CITY OF ST. PETERSBURG, FLORIDA
PLANNING AND DEVELOPMENT SERVICES DEPARTMENT
URBAN PLANNING AND HISTORIC PRESERVATION DIVISION

STAFF REPORT

Community Planning and Preservation Commission
Certificate of Appropriateness Request

Case No.:	22-90200054
REQUEST:	Review of a Certificate of Appropriateness application for the replacement of windows and after-the-fact replacement of front door at 3234 9 th Ave N, a contributing property to a local historic district
OWNER:	H.E.A.T. Concepts Inc
APPLICANT:	Andres Pena
ADDRESS:	3234 9 th Ave N
LEGAL DESCRIPTION:	KENWOOD SUB ADD BLK 14, LOT 5
PARCEL ID NO.:	14-31-16-46350-021-0040
LOCAL LANDMARK:	Kenwood Section – Northwest Kenwood Local Historic District

Figure 2: Example of the window that was original to 3234 9th Ave N. Image from the City of Anaheim's "Architectural Style Guide: Minimal Traditional."

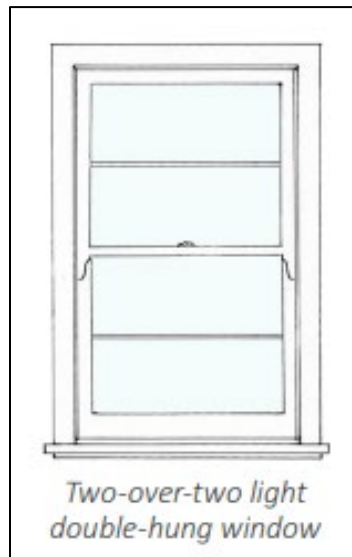
Staff had photographed the house in November 2021 as part of a roof final inspection, where the structure's original double-hung, wood windows were visible with a two-over-two horizontal light configuration. This configuration of window was commonly utilized in the 1930s and the 1940s as architecture shifted to a more modern/streamlined aesthetic. It is also a common window used in Minimal

Consistent The two-over-two horizontal oriented configuration will be replicated.

Figure 4: Proposed Jeld-Wen window.

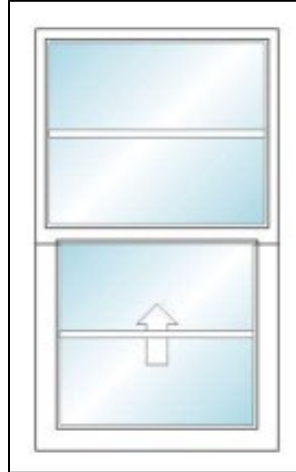
COA application 22-90200054 proposes the replacement of the recently installed windows, which did not receive a Certificate of Appropriateness or a building permit. The windows installed are aluminum, non-impact resistant, do not feature a grille to replicate the traditional muntin pattern, and were not installed with a traditional two-to-three-inch reveal. The applicant is proposing to install new Jeld-Wen vinyl windows that are impact resistant and will replicate the horizontal two-over-two window configuration.

The proposed windows are a different material than extant or original windows (vinyl is proposed to replace the original wood windows and the not approved aluminum windows), but the configuration/design and operation will be retained.

Inconsistent The window frames are vinyl, which is a visually modern material.

1. Windows will be installed to be setback within the wall plane and feature a reveal of at least two inches, to match the historic window reveal.
2. Windows will be feature external, three-dimensional contoured grilles to replicate traditional muntins, and the muntin pattern will replicate the two-over-two horizontal oriented configuration as depicted in the application and this staff report.
3. A historic preservation final inspection is required.
4. All other necessary permits shall be obtained. Any additional work shall be presented to staff for determination of the necessity of additional COA approval.
5. This approval will be valid for 24 months from the date of this hearing, with an expiration date of July 12, 2024.

3234 9TH AVE N

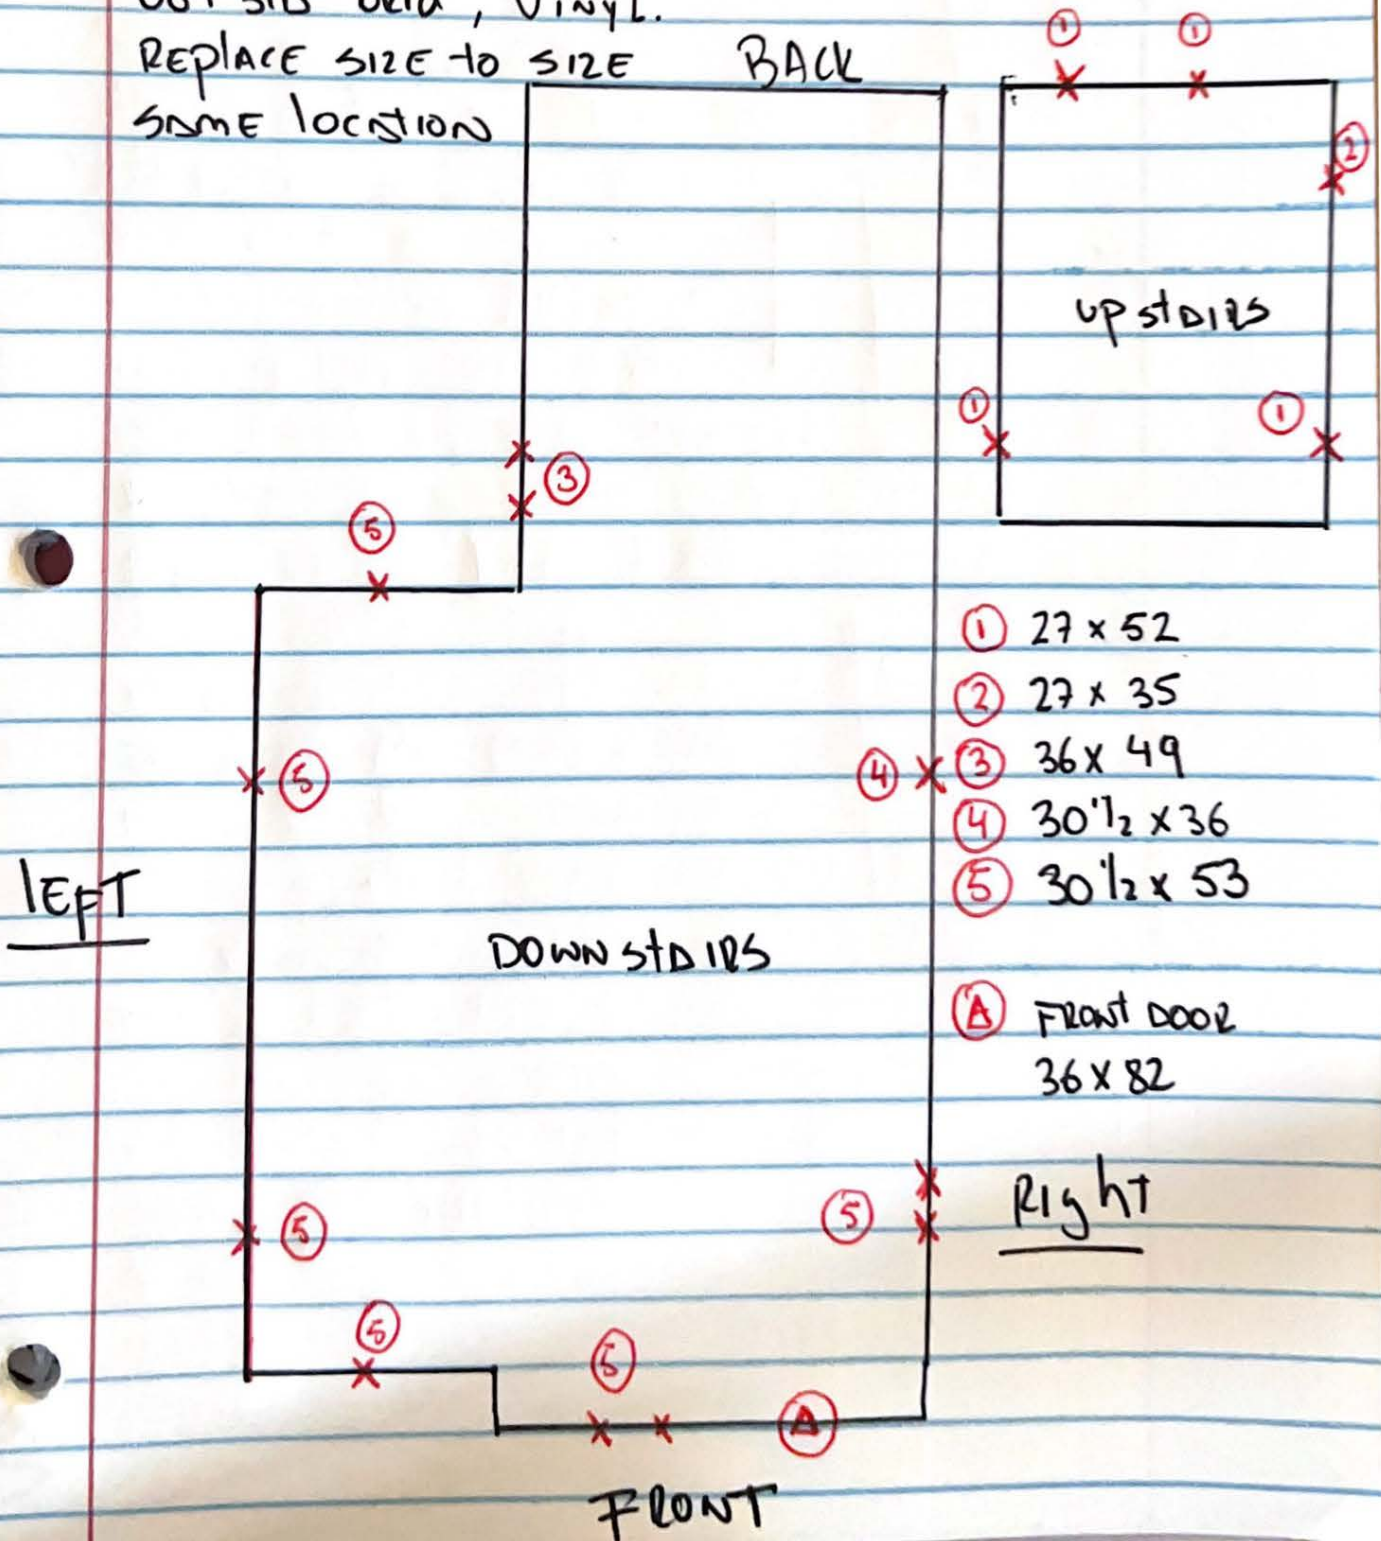
- IMPACT windows sold w/ new out sid grid, Vinyl.

REPLACE SIZE TO SIZE SAME LOCATION
